<b>Project</b>	IEEE 802.16 Broadband Wireless Access Working Group < <a href="http://ieee802.org/16">http://ieee802.org/16</a> >	
<b>Title</b>	<b>Action Item from Session #46: Text and Figure fixing comment 544</b>	
<b>Date Submitted</b>	2007-01-16	
<b>Source(s)</b>	<p><b>Liwen Chu</b> STMicroelectronics 1060 East Brokaw Road San Jose, CA, USA</p> <p><b>Kyeongsoo Kim</b> STMicroelectronics 1060 East Brokaw Road San Jose, CA, USA</p>	<p><b>Voice: 1-408-467-8436</b> <b>Fax: 1-408-452-0278</b> <a href="mailto:liwen.chu@st.com">liwen.chu@st.com</a></p> <p><b>Voice: 1-408-621-4913</b> <b>Fax: 1-408-452-0278</b> <a href="mailto:kyeongsoo.kim@st.com">kyeongsoo.kim@st.com</a></p>
<b>Re:</b>	<b>IEEE 802.16 Working Group Letter Ballot #24, on P802.16h/D1</b>	
<b>Abstract</b>	<b>This contribution proposes to enhance adaptive channel selection using 2-hop BS working channel ID to increase spatial efficiency.</b>

**Action Item from Session #46: Text and Figure fixing comment 544  
 ----Enhancements to the Optimization of channel Distribution**

The process of ACS is shown in Figure h 38. The ACS process concludes with either one of two possible results: a) a "free" channel is validated with or without channel distribution optimization, or b) no "free" channel.

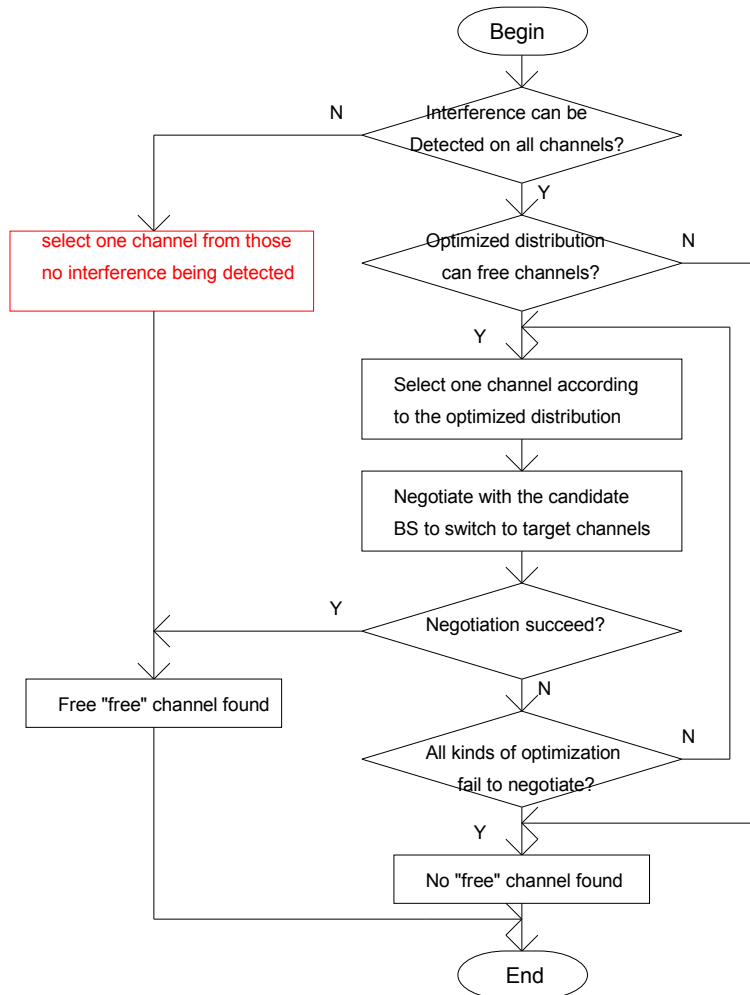
If there is neither interference detected nor interference victims found in some channel by the IBS, the channel is marked as a "free" channel of the IBS. **When the IBS can find non-interfering channels at the initialization phase, it shall select its working channel as follows:**

**If the IBS can find non-interfering channels that are also its 2-hop neighbors' working channels, it randomly selects one from those non-interfering channels as its working channel.**

**Otherwise the IBS randomly selects one from all available non-interfering channels as its working channel.**

Change Figure h38 as follows:
